# Report to Development Permit Panel

DP 04-275373

Application by Gomberoff Bell Lyon Architects for a Development Permit at

9171 Ferndale Road

UNIT D - accessible units (FOUR PROPOSED)
2 BED & DEN (967 SQ.FT)

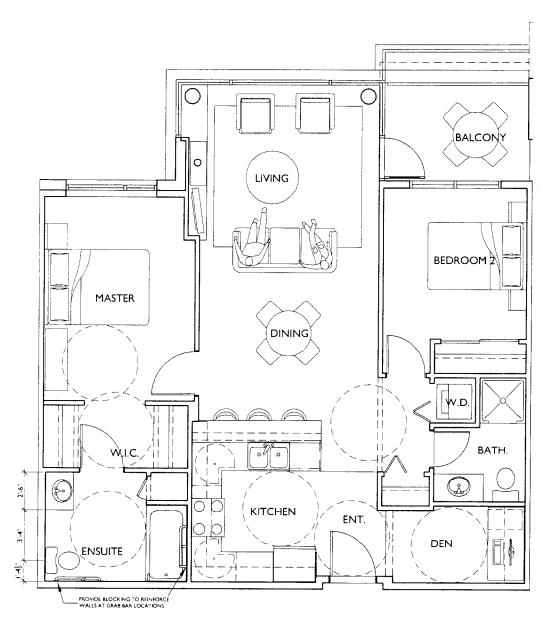
• The bathroom fixtures would be difficult to adapt for accessible use. Mr. Goodwin said that the size of the units would allow for some flexibility and that Mr. Johnson's comments would be investigated.

(This project provides four (4) wheelchair accessible units (see Attachment 3 - modified Unit D). In addition, blocking inside of the walls will be provided in all washrooms in the mid-rise building to facilitate future installation of grab bars/handrails to encourage universal accessibility.)
